| | PCN Number: 2024 | | | 0327005.1 PCN Date: | | | March 28, 2024 | | | |
| Title | e: | • | | AB using qualified Process Technology, Die Revision, and | | | | | | |

PCN Details

Sample product shipping label (not actual product label)

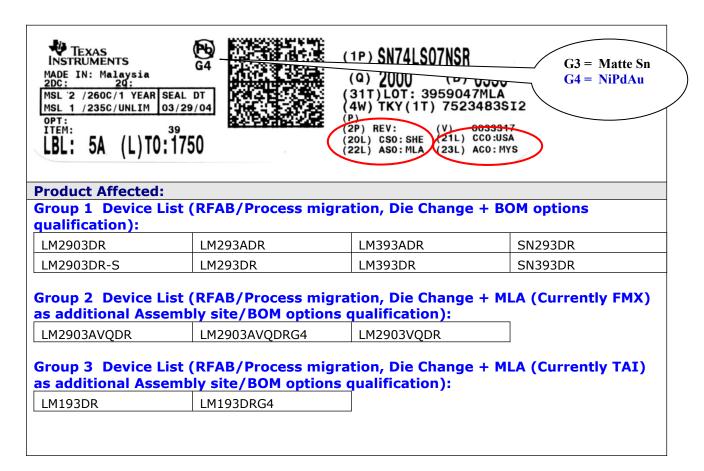
Changes to product identification resulting from this PCN:

Fab Site Information:
